City of Del Mar Staff Report

SUBJECT: Continuation of Hearing for the Adoption of a Resolution Approving a *Design Review Permit* (DRB15-017), *Coastal Development Permit* (CDP15-010), *Land Conservation Permit* (LC15-008), and *Tree Removal Permit* (TRP15-014) for the City Hall/Town Hall/Plaza Project Located at 1050 Camino del Mar in the Public Facilities Zone along with Potential Design Changes to Address Community Comments

2. Privacy, noise and glare issues to adjacent property owners along the western, southwestern and northwestern sides

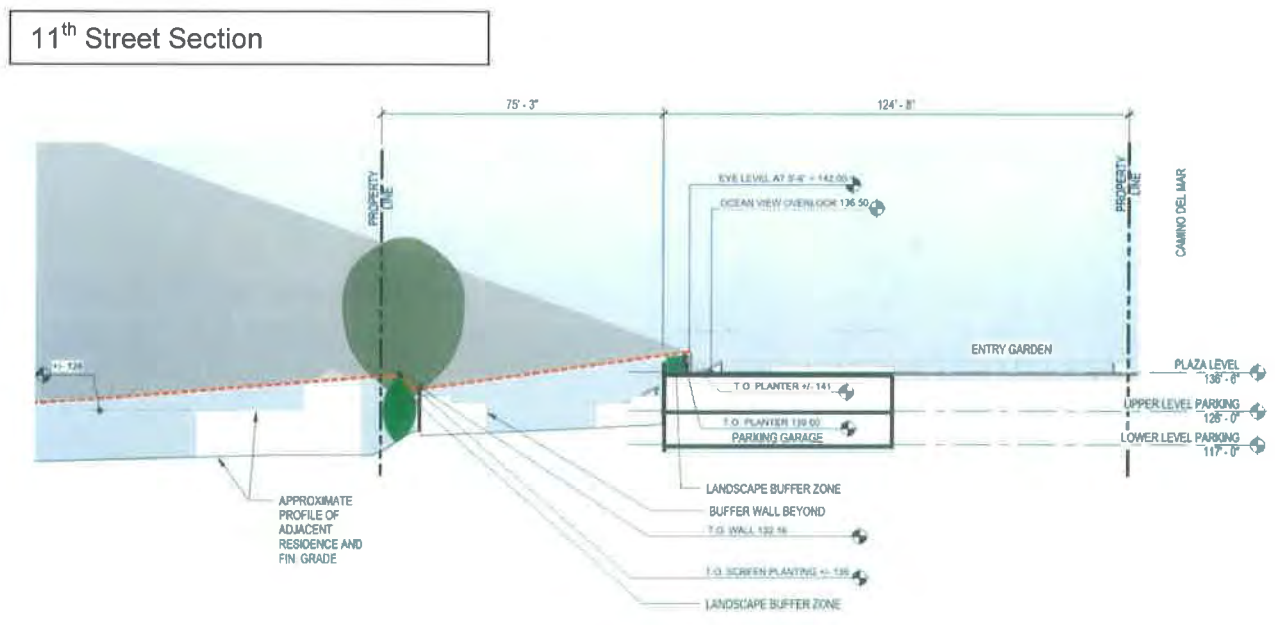
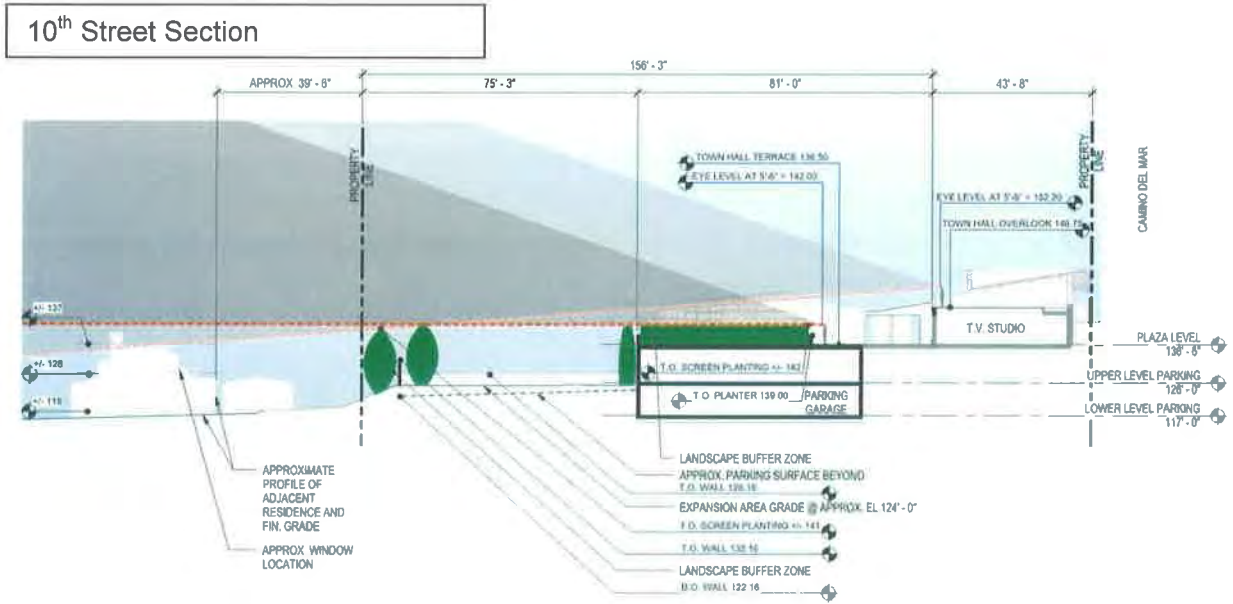
Option for addition of planting up to elevation 142, a 10 foot screen wall on the western setback line (10 feet from property line) and 6 foot screen walls with planting to screen the north and south ends of the parking lot per the diagrams below.

3. Traffic circulation and distribution

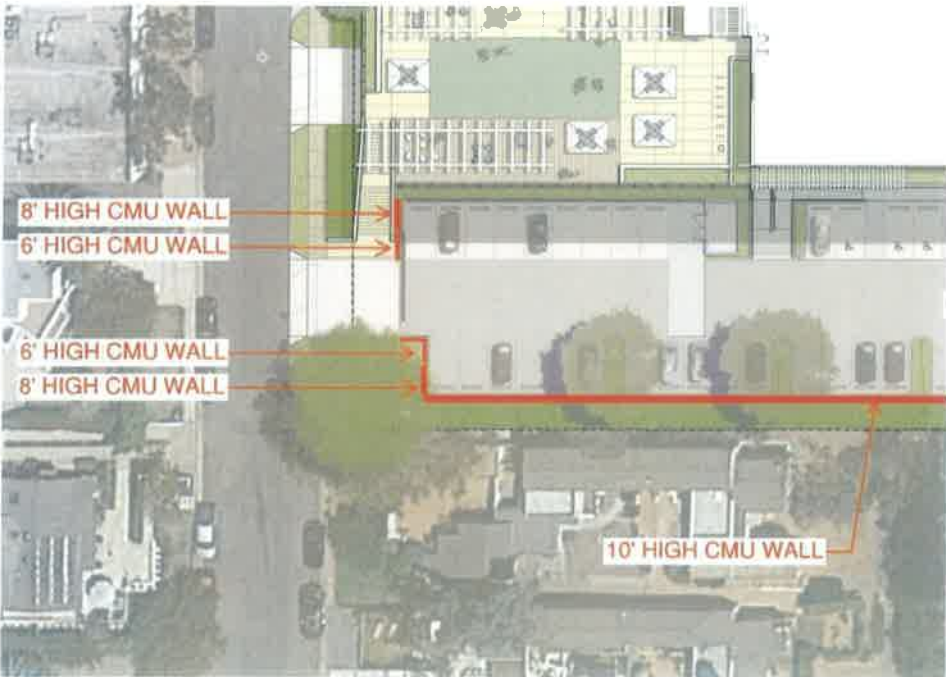
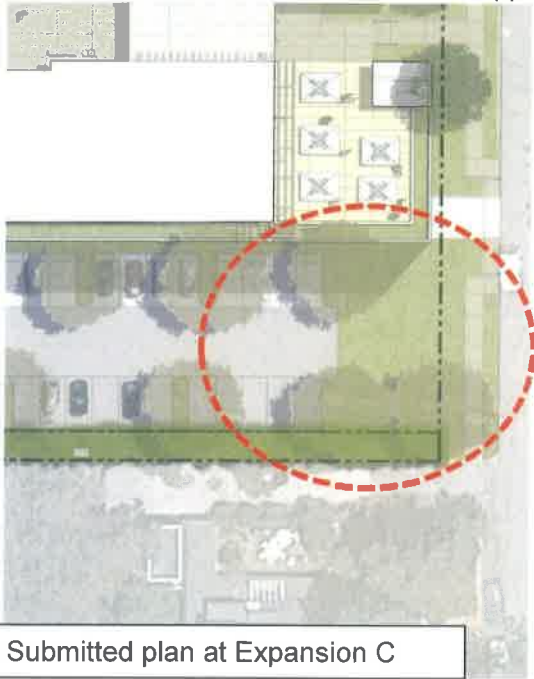
Option to gate the surface parking lot at 11th Street for regular use, and limit that 11th Street gated access to emergency and high profile vehicles or special events (Farmer's Market, etc.). In addition, provide a connection between the parking garage and the surface parking lot. This will direct access away from the adjacent residential and direct egress closer to Camino del Mar. The location of the connection (driveway) would be in line with the alley to the west rather than opposite residential. There is no connection to the alley due to grade differential. This option promotes visitors to park in the garage first before using the surface lot.

Submitted plan at Expansion C

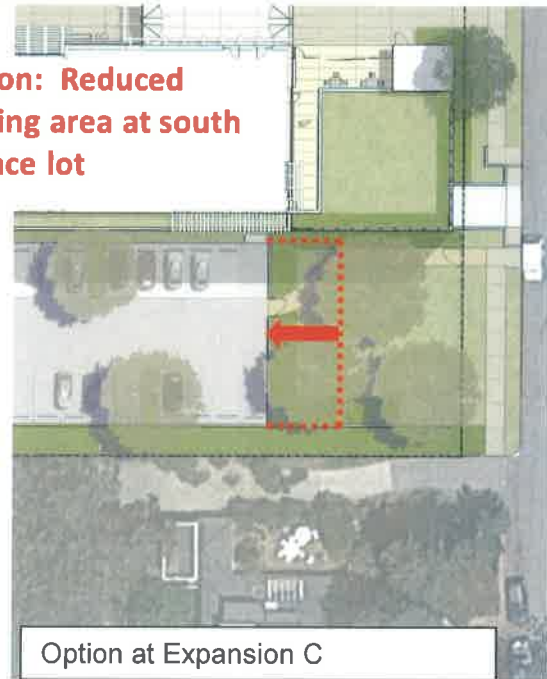
Various comments asked for specific parking areas to be removed, either under the existing eucalyptus tree to remain along 11th Street or in Expansion Area C, along 10th Street. These options reduce the parking from a maximum of 160 stalls to approximately 150 stalls.

- **Option: Reduced Parking area at south surface lot**

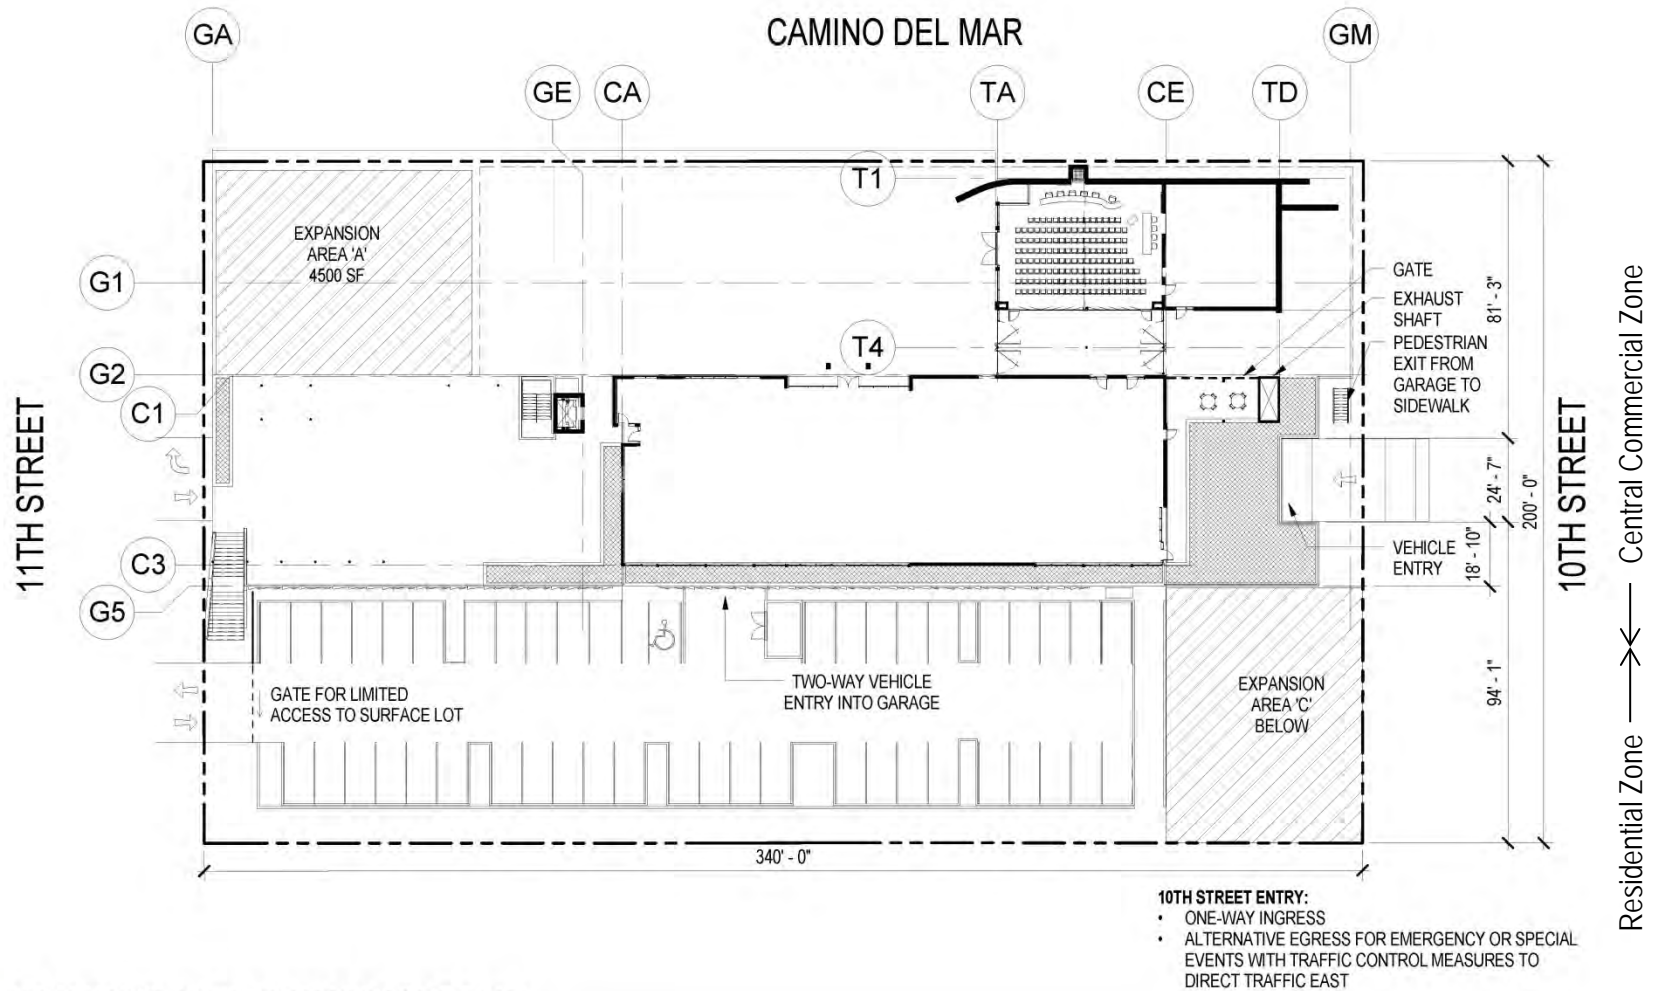
- 1) One set of Ingress and Egress on 10th street with traffic directed to Camino Del Mar only, so left turn on 10th street only. This ingress and egress to remain open at all times and with special events, Further measures are to be employed to ensure no traffic goes west from ingress/egress on 10th Street during events.
- 2) Ingress and Egress on 11th street with traffic directed to Camino Del Mar only, so right hand turn only. This ingress and egress to remain open at all times and with special events. Further measures are to be employed to ensure no traffic goes west on 11th Street ingress/egress at garage during events.
- 3) Surface Parking lot ingress/egress on 11th street is to be locked with a keyed gate at **all times** with the exception of three instances:
 - in an emergency
 - farmers market
 - only for large service vehicles that cannot access the garage.

There was an additional vote that **NO ACCESS WILL BE GIVEN AT SPECIAL EVENTS THROUGH THE INGRESS/EGRESS TO AND FROM THE SURFACE PARKING LOT ON 11TH STREET.** This was a unanimous vote by all attending. Additionally, It was stated by one traffic engineer attending that using this for any special events would be unwise for traffic circulation given the 11th street ingress/egress at the garage.
